## Introduction of laser marking for Vishay Cera-Mite

# Product Change Notification

Product Group: Vishay Ceramic Capacitors / December 23, 2019 / PCN-CC-001-2018 Rev 1

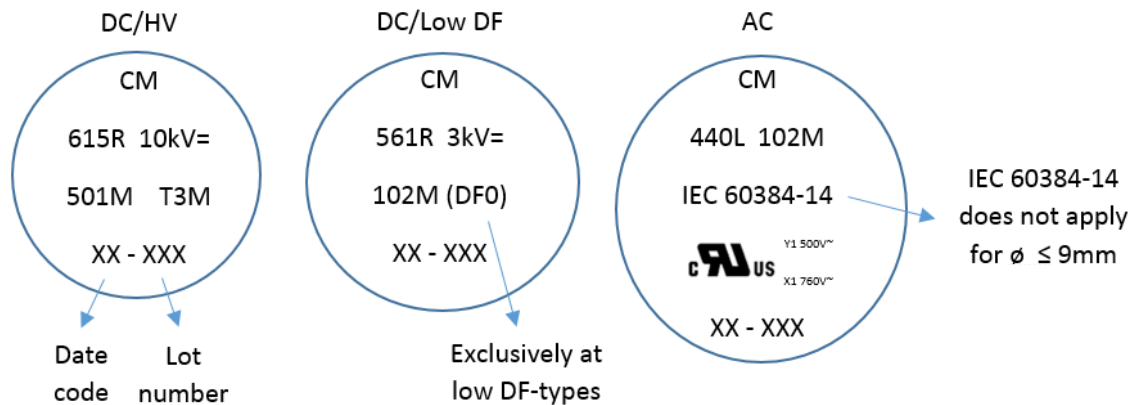
**DESCRIPTION OF CHANGE:** In line with our commitment for continuous improvement we additionally introduce laser marking along with a modified marking including date code and lot number for Vishay Cera-Mite components. Both marking technologies, existing tampon-print as well as new laser marking, will be used in parallel. The existing tampon-print marking will show neither a date-code nor a lot number. During introduction period, deliveries of affected products with mixed marking method are possible. The labeling will change accordingly. There is no discontinuation of any components. The modified marking will be as follows with the certificate issued by Underwriters Laboratories Inc. combining the former UL and CSA certificate:
